# THE SOUTH CAROLINA OFFICE OF REGULATORY STAFF

#### **DOCKET NO. 2023-9-E**

# Review of Dominion Energy South Carolina, Incorporated's 2023 Integrated Resource Plan

Figure 2

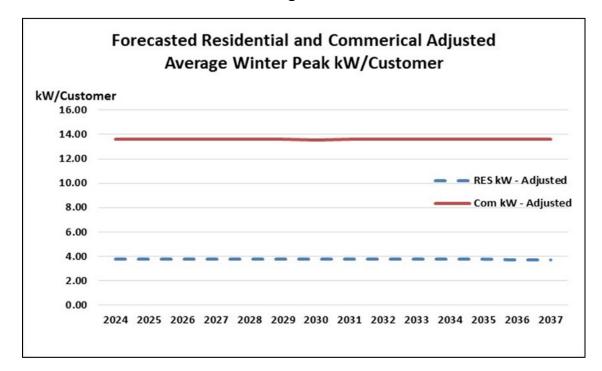
The figure indicates there is essentially no change in the average winter peak kW per customer during the entire forecast period. At the same time, the Company projected changes in residential and commercial average kWh use per customer during this same period. Based on the energy forecast results presented in Company Witness Perricelli's Tables 1 and 2, Residential Class average use per customer in 2037 is projected to be 13,116 kWh, compared to 2023 average residential use of 12,501 kWh per customer. This reflects a cumulative growth rate of 4.9% in average use during the period. For the commercial class, a similar calculation produces a cumulative growth rate in average kWh/customer usage of 5% during the period. The cumulative growth rate in the residential class and commercial class winter peak kW/customer are 0% and 0% respectively, even after accounting for adjustments for energy efficiency and EV. Table 7 below summarizes this comparison.

B1. DESC should perform more detailed analyses to assess the reasonableness of its Residential and Commercial class peak load forecasts in future IRPs, and in particular, the Company should provide support for the assumption that the average peak load per

Figure 8: Industry Comparison of CO<sub>2</sub> forecasts

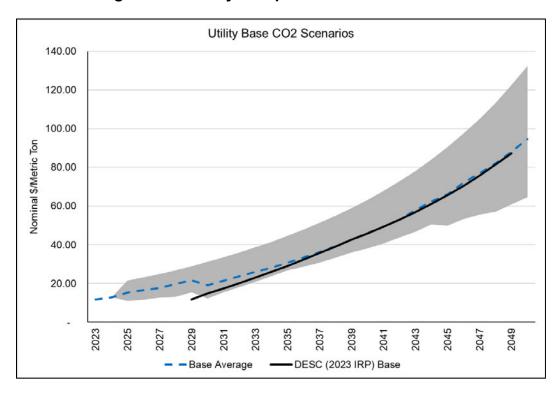
Figure 8 indicates that DESC's base forecast is reasonable versus the comparison forecasts. Figure 9 below provides a comparison of the CO<sub>2</sub> forecasts that DESC used between the 2021 IRP Update and 2023 IRP. The Company stated that the same low, medium, and high CO<sub>2</sub> scenarios were used in the 2023 IRP compared to the 2022 IRP Update.<sup>49</sup> ORS recommends that the CO<sub>2</sub> forecasts continue to be discussed in the Stakeholder Working Group. ORS's recommendation is based on the fact that a CO<sub>2</sub> tax has never been imposed at the Federal level or by the State of South Carolina, and there are renewable market incentives that could justify a lower price forecast, whereas pending CO<sub>2</sub> rules under the Clean Air Act could justify a higher price forecast.

Figure 10: Capacity Factor at DESC Gas Plants (%)

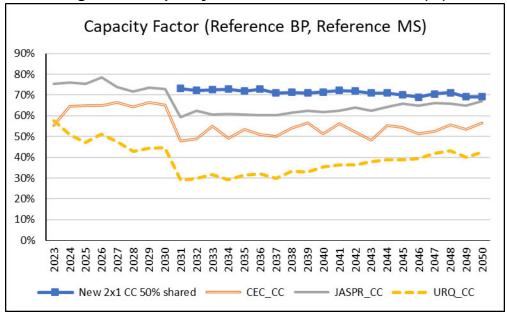
Figure 10 demonstrates most of DESC's CC units may be affected by the Proposed GHG Rules. The Proposed GHG Rules may also impact the operation of DESC's coal units, depending on when the Company finalizes the retirement decisions for Wateree and Williams.<sup>72</sup> ORS recommends DESC discuss the possible impacts of the Proposed GHG Rules in Rebuttal Testimony, especially in light of the joint resource decision, and the Wateree/Williams retirement decisions.
